14. DESCRIPTION OF AMENDMENT/MODIFICATION (Organized by UCF section headings, including solicitation/contract subject matter where feasible.) N40085-15-Q-7610, Relocate Fire Alarm Devices, Bldg. 311, Naval Support Activity (NSA), Mechanicsburg, PA 1. The purpose of this amendment is to provide answers to Request for Information received. Questions and responses are attached on Page 2. 2. Date for receipt of quotations is hereby changed from 5 June 2015 at 3:00 PM EST to read 9 June 2015 at 3:00 PM EST.				
Except as provided herein, all terms and conditions of the document referenced in Item 9A or 10A, as heretofore changed, remains unchanged and in full force and effect.				
15A. NAME AND TITLE OF SIGNER (Type or print)		16A. NAME AND TITLE OF CONTRACTING OFFICER (Type or print) CHRISTINE SHOLTZ / CONTRACT SPECIALIST ROME, NY TEL: (315) 709-5273 EMAIL: christine.sholtz@navy.mil		
15B. CONTRACTOR/OFFEROR (Signature of person authorized to sign)	15C. DATE SIGNED	16B. UNITED STATES OF AMERICA BY _____ (Signature of Contracting Officer)	16C. DATE SIGNED 02-Jun-2015

QUESTIONS/RESPONSES

BUILDING 311 - SECOND FLOOR FIRE ALARM DRAWING
SCALE: 3/32" = 1'-0"

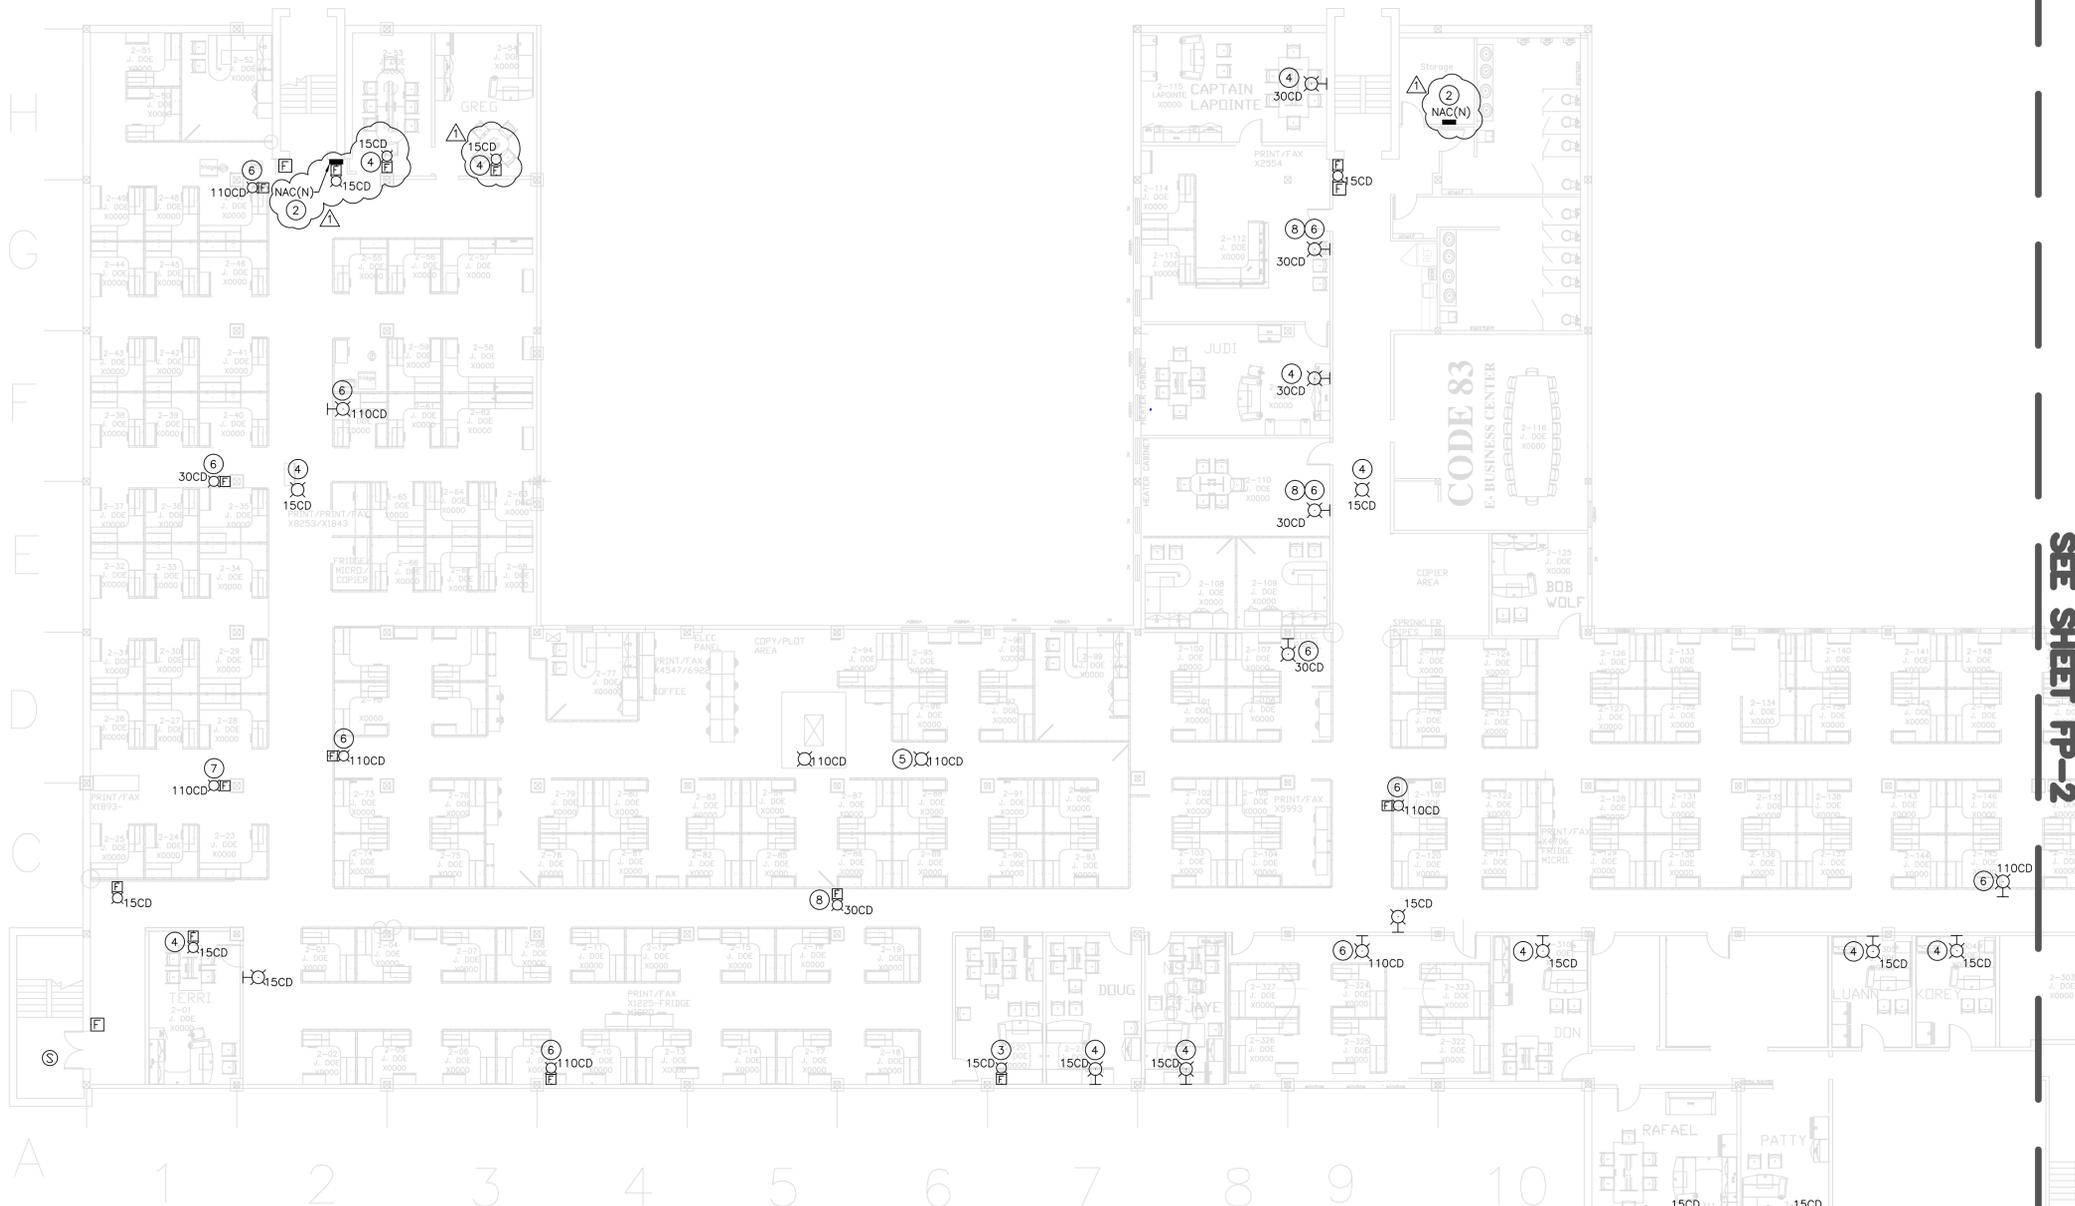
1. Would it be possible for me to get catalog cuts and or descriptive data on the equipment (NAC panels, Main panel, and the alarm devises) used for this project? I also would like to know the wire specifications as well as a one line diagram for the work performed in Phase A.
RESPONSE: No catalog cuts or descriptive data on the equipment is available. Contractor shall comply with all fire alarm codes to determine wire specifications.
2. For clarification purposes, two additional drawings (no. 12684741 and 12684742) are attached for additional information as necessary.
